Classification:  
TF15-002

Reference:  
ITB15-014

## 2013 JX35 AND 2014 QX60 AWD ERROR DISPLAYED AND DTC C1204 STORED

**APPLIED VEHICLES:**      2013 JX35 (L50)  
   2014 QX60 (L50)  
   2014 QX60 Hybrid (L50) } Equipped with AWD

Figure 2

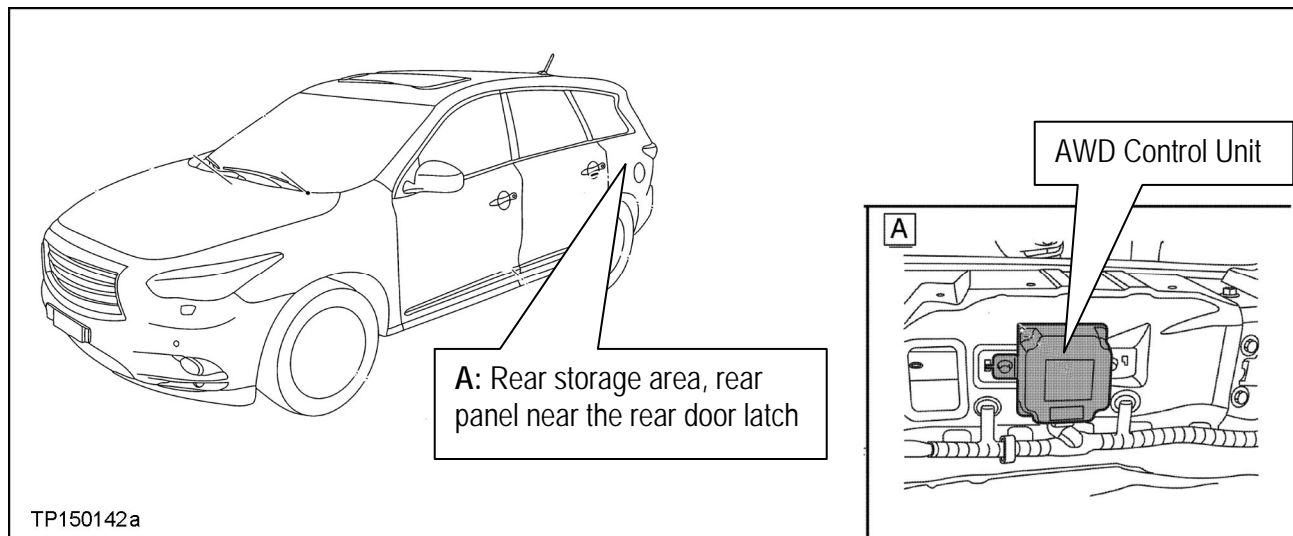
Replace the AWD Control Unit with the one listed in the Parts Information below (see Figure 2).

- Refer to the Electronic Service Manual (ESM), section DLN-Driveline, for replacement information.
